1. The Reset Button Does Not Function

2. PCI 9054's PME# Pin Connects Directly to PCI Connector's PME# Pin

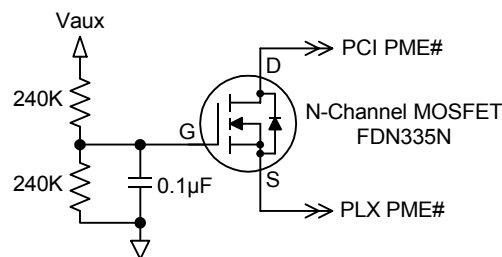
On the PCI 9054RDK-LITE, the PCI 9054's open collector PME# pin (167) connects directly to the PCI connector's PME# pin (A19). This violates the PME# electrical requirements detailed in the *PCI Bus Power Management Interface Specification, Revision 1.1, December 18, 1998*, Chapter 7, Power Management Events, paragraph 7 of page 55 through all of page 57. As a result, inserting the RDK into a PCI slot while the system is in a low-power state could cause the system to detect an unintentional PME# assertion and consequently wake up.

2. If the application requires that the RDK generate power management events (i.e., PME# assertions are required), to add the required isolation of the PCI 9054's PME# pin from the PCI Connector's PME# pin, refer to the circuit diagram in the Implementation Note on page 57 of the *PCI Bus Power Management Interface Specification, Revision 1.1, December 18, 1998* (also re-printed as Figure 23-17 on page 534 of *PCI System Architecture, Fourth Edition*, by Tom Shanley and Don Anderson). If you use an FDN335N N-channel MOSFET for this circuit, since this MOSFET has an internal protection diode between its source (diode anode) and drain (diode cathode), the source and drain must be reversed from those shown in the circuit diagram. The following circuit diagram illustrates this:
